Architect's Supplemental Instructions Addendum

Project: Samish Xwch'ángteng Development on 34th Street
Anacortes, WA

Addendum/ASI No.: Addendum 03
Date of Issuance: May 23th, 2022

TYP. WALL SECTION

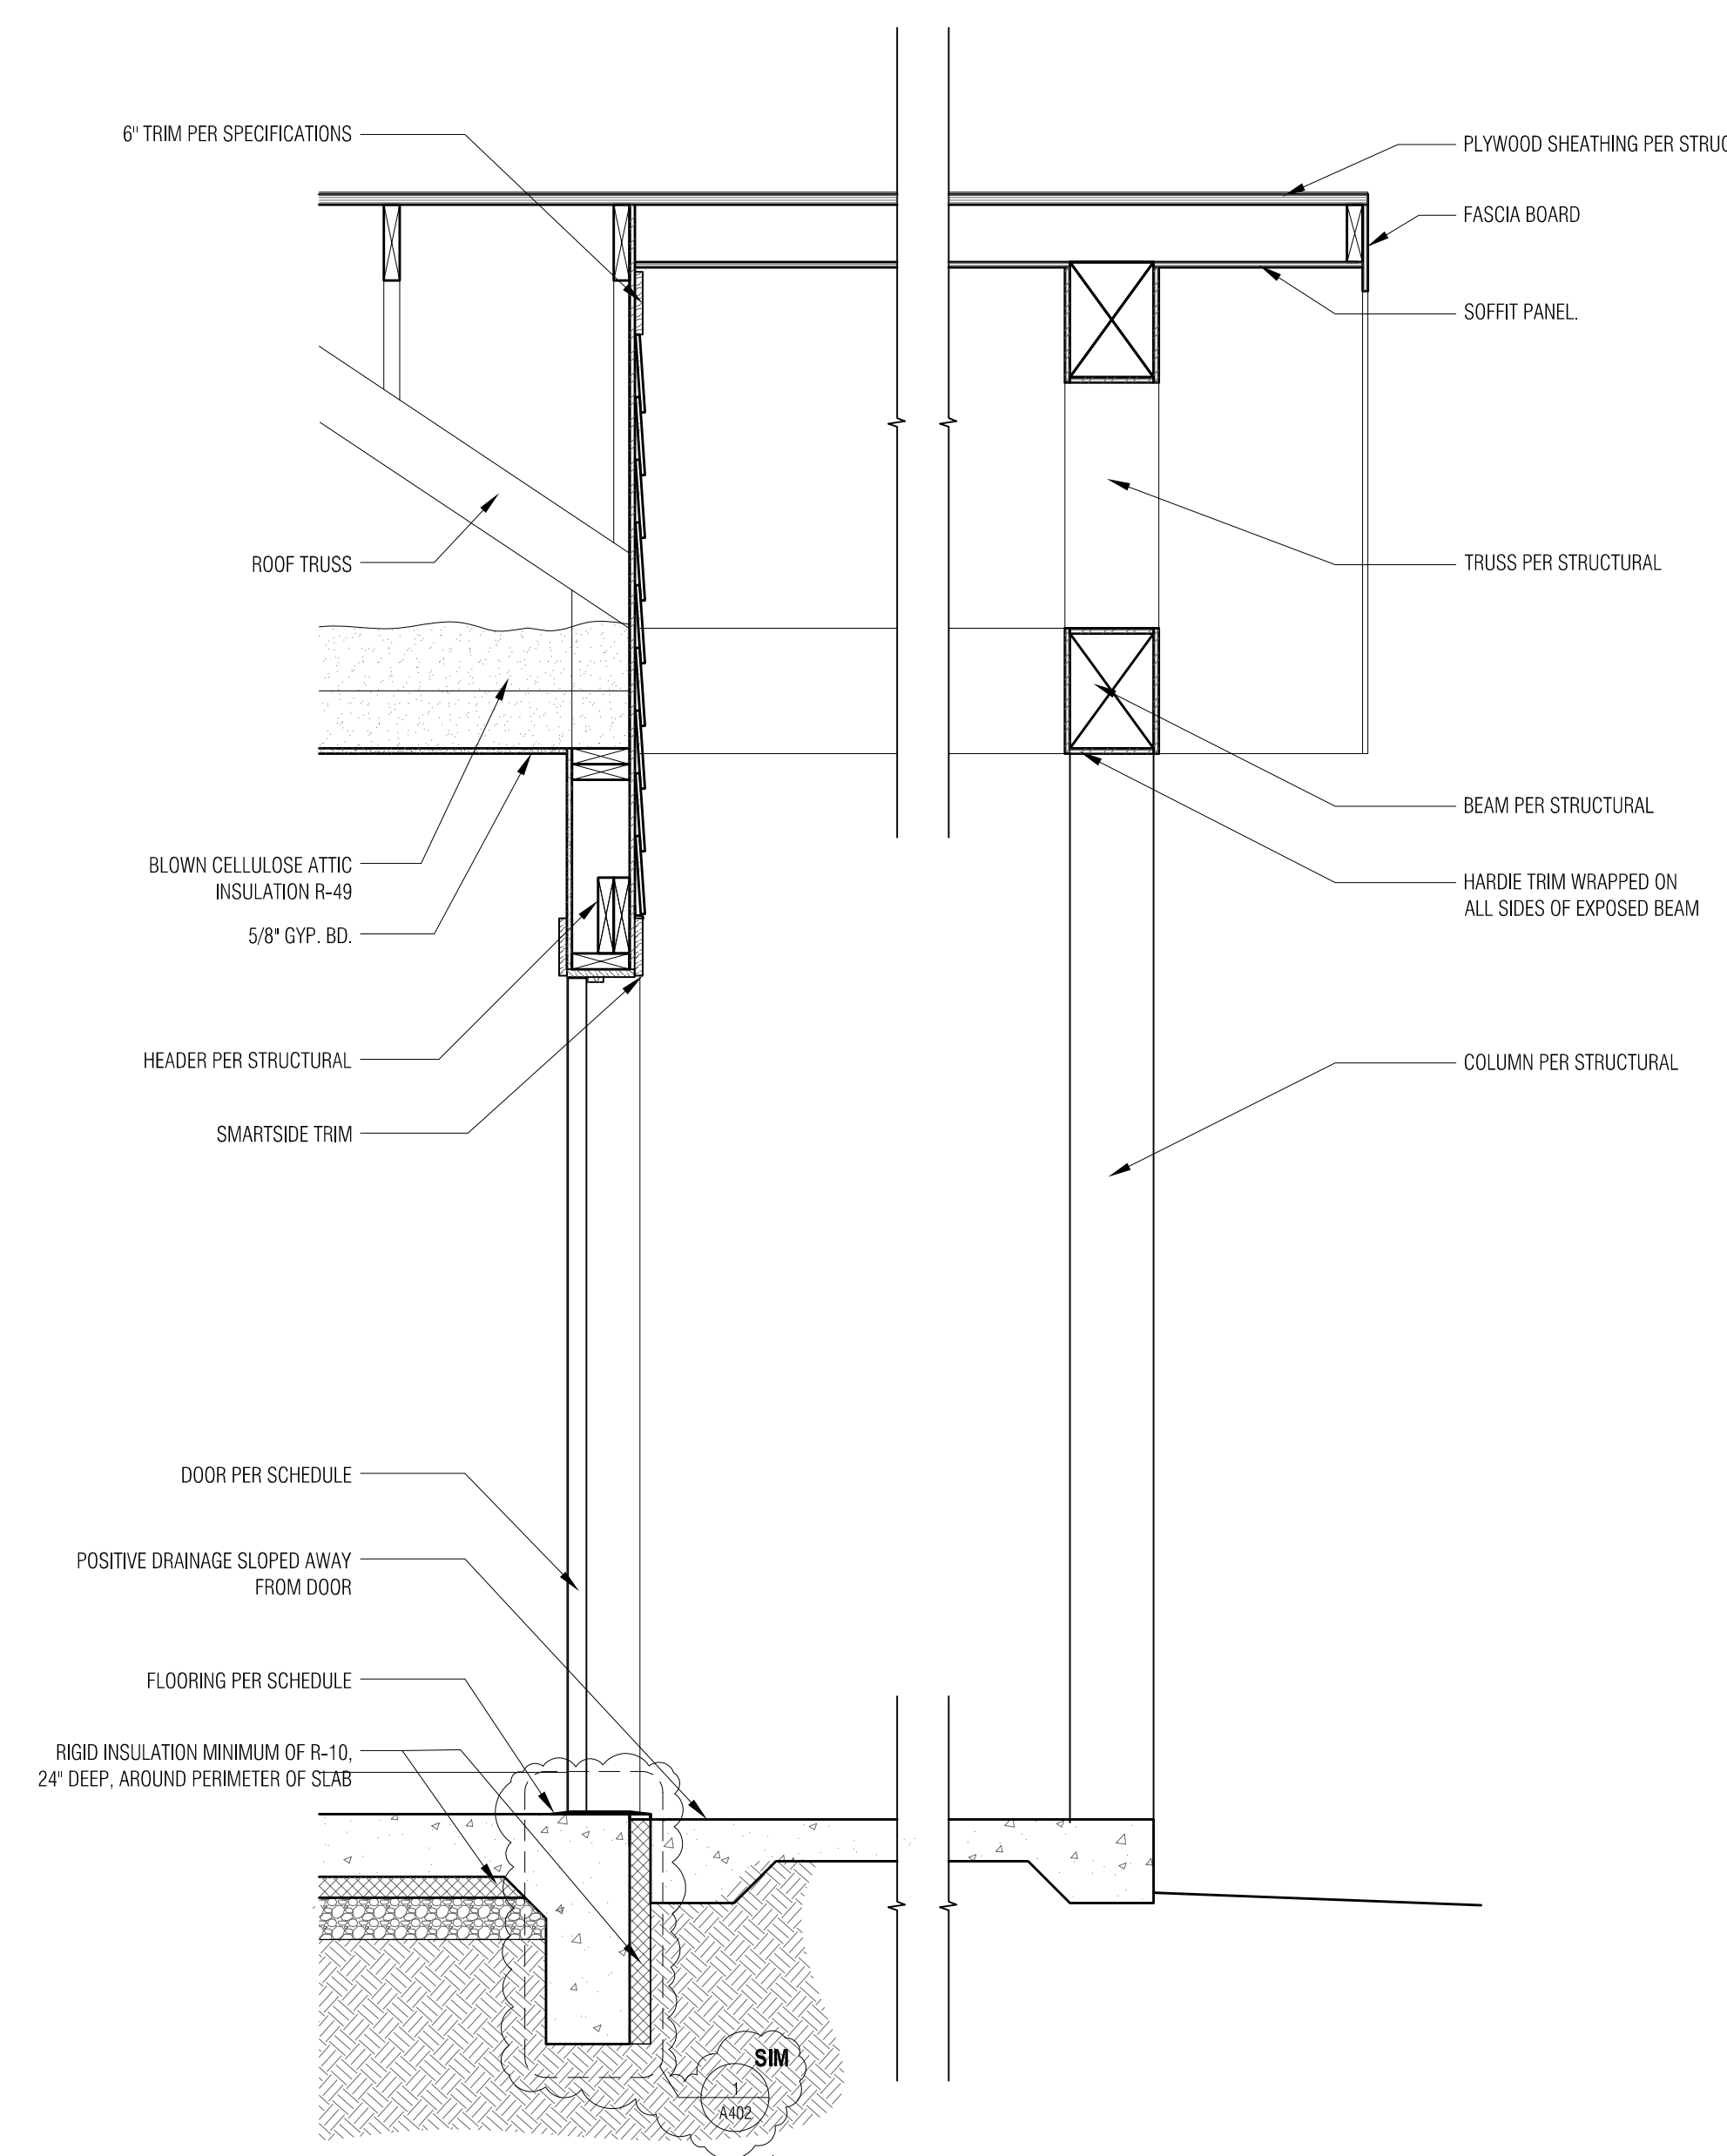
31. City of Anacortes approved set comments A401.: **Provide thermal break at exterior to conditioned slabs.** Typical [see attached revised sheets A401 & A402](#)

4. Sheet A301 **WINDOW TYPE LABEL UPDATED**
5. Sheet A400 Details 1, 2, 3 **CHANGED EXTERIOR INSULATION CHAMFER PROFILE**
6. Sheet A401 Details 1,2 **ADDED THERMAL BREAK INSULATION**, Detail 3 **CHANGED EXTERIOR INSULATION CHAMFER PROFILE**

**COTTAGE FLOOR PLAN - HVAC**
1/4" = 1'-0"

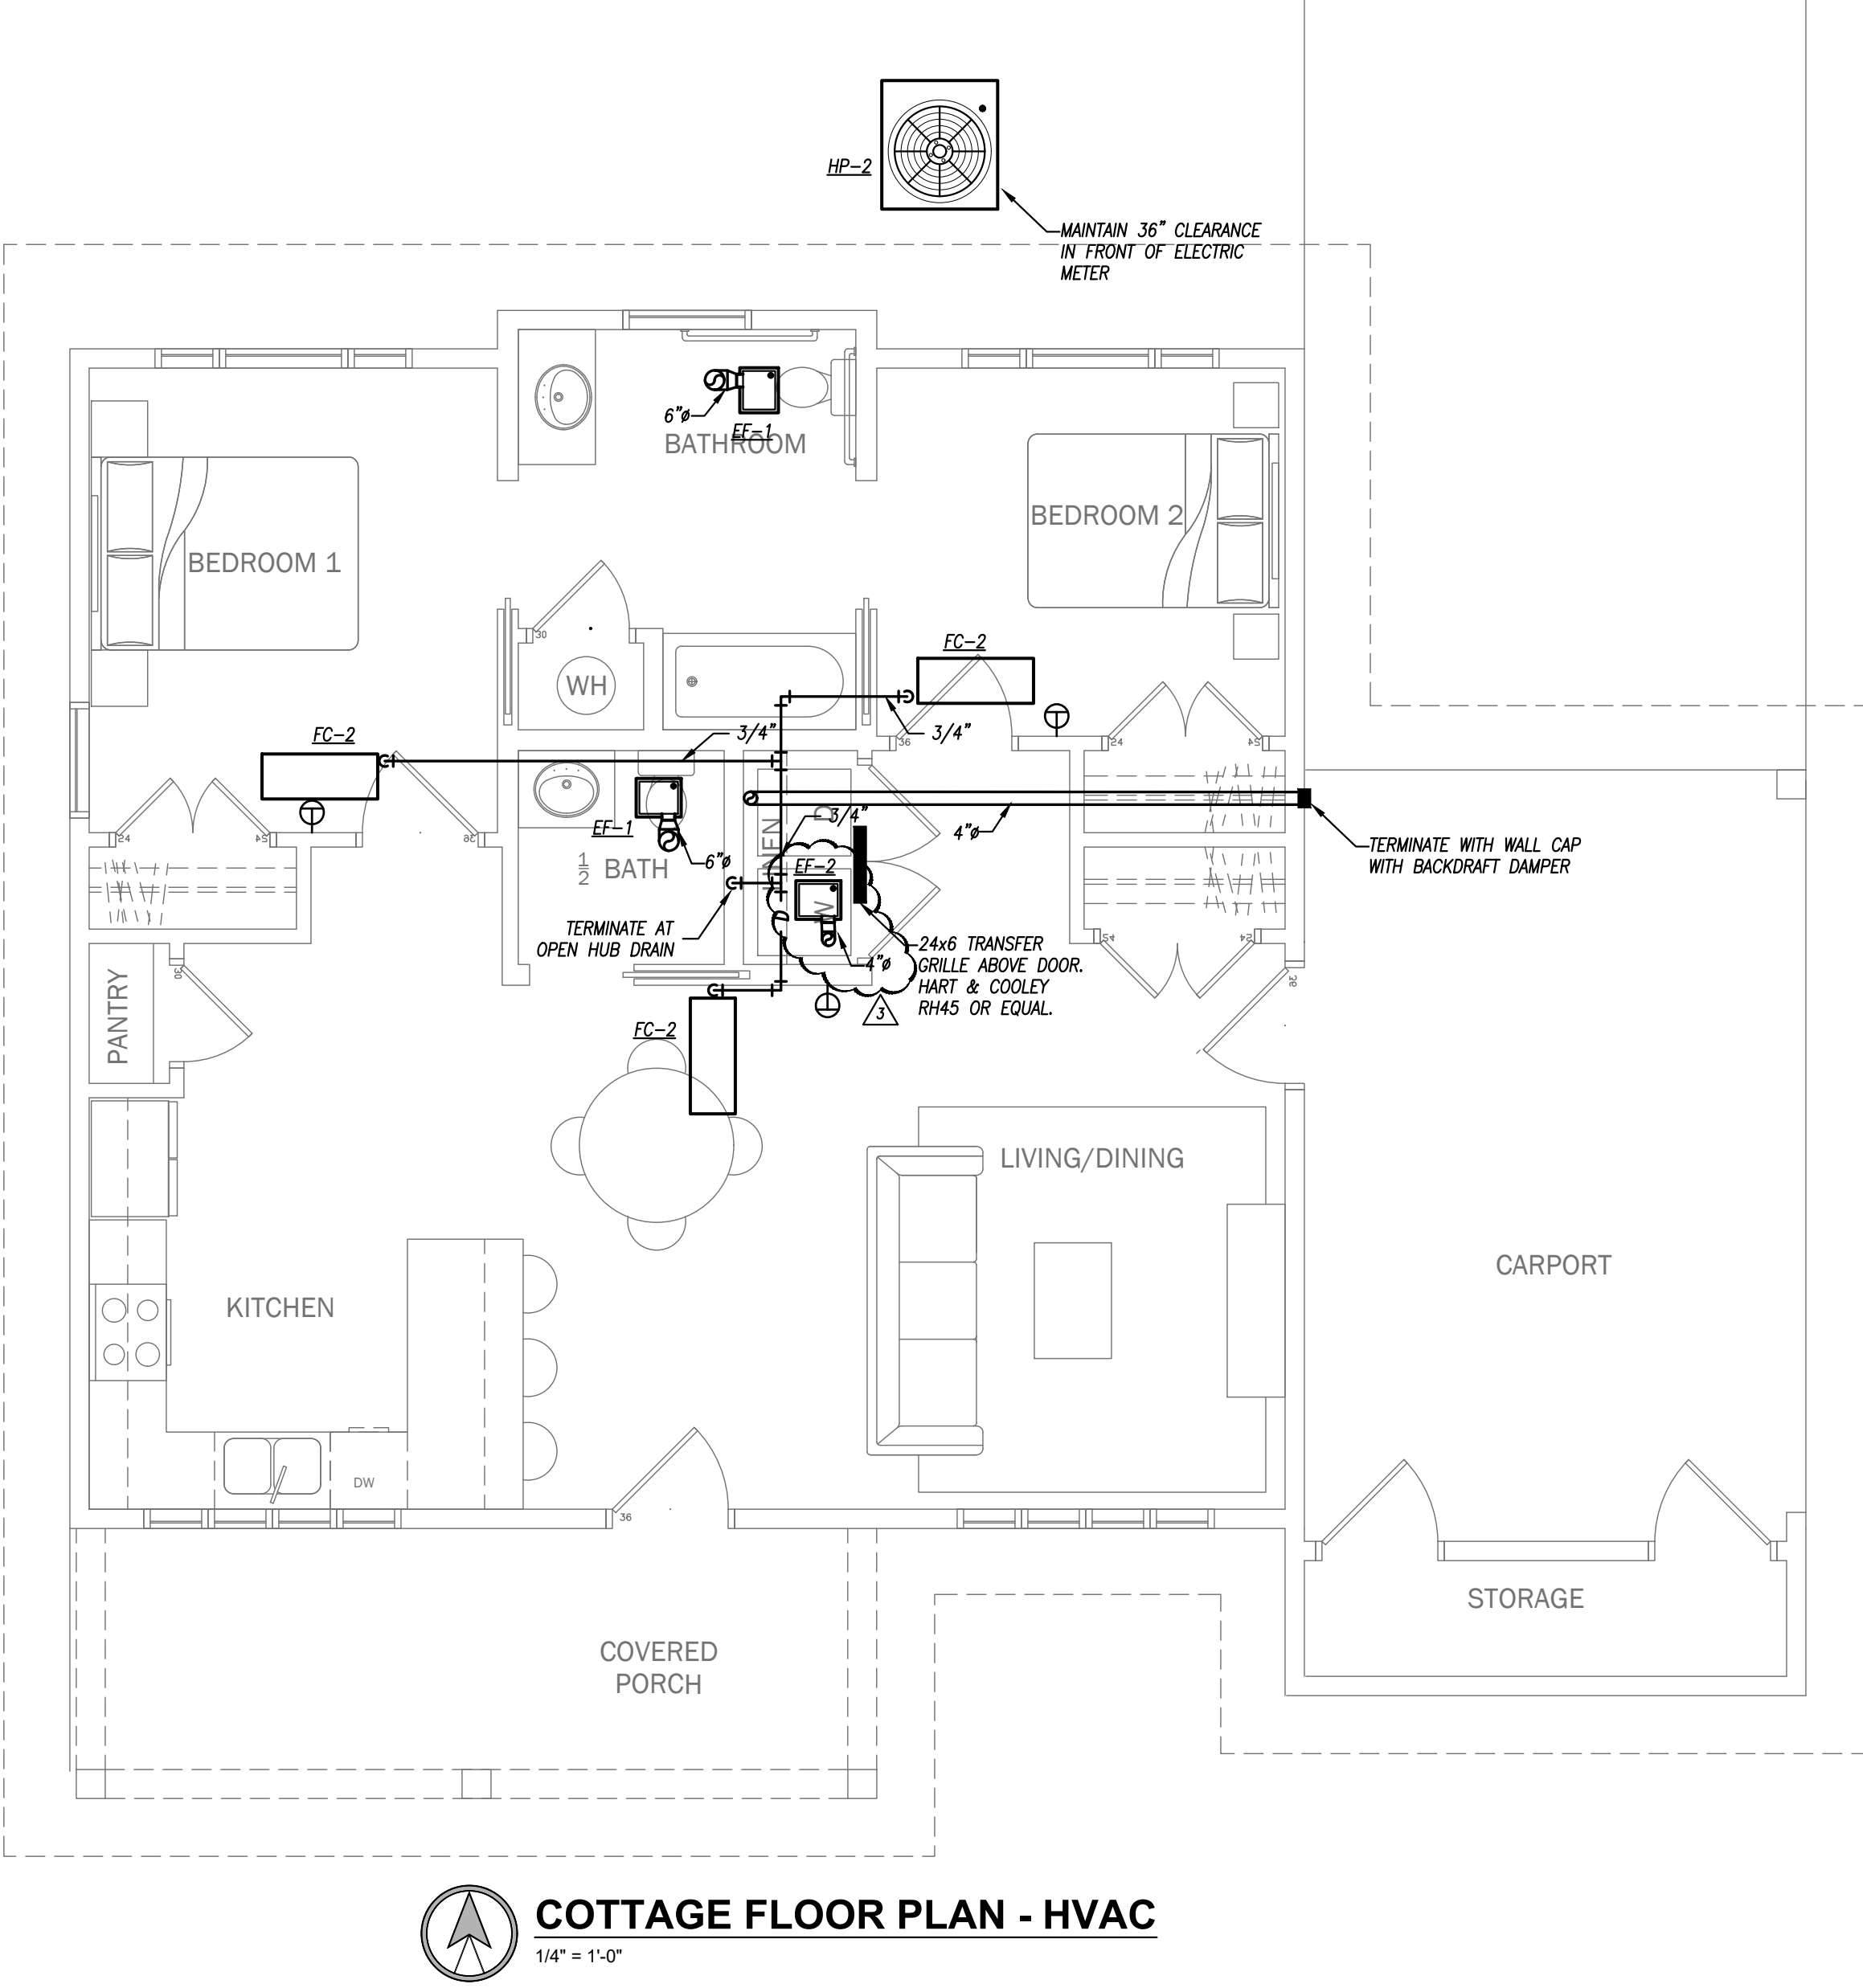
29. City of Anacortes Approved set comments M-101, M102: **50 cfm vent fan required in laundry closets.** [See revised sheets M-101, M-102, M-201](#)
30. City of Anacortes approved set comments ATS: **Energy credits table added to cover sheet** [see general note #19](#)

10. Sheet M-101 **ADD EXHAUST FAN**
11. Sheet M-102 **ADD EXHAUST FAN**
12. Sheet M-201 **ADD EXHAUST FAN**
13. Sheet E-101 **ADD DOOR CHIME**
14. Sheet E-102 **ADD DOOR CHIME**
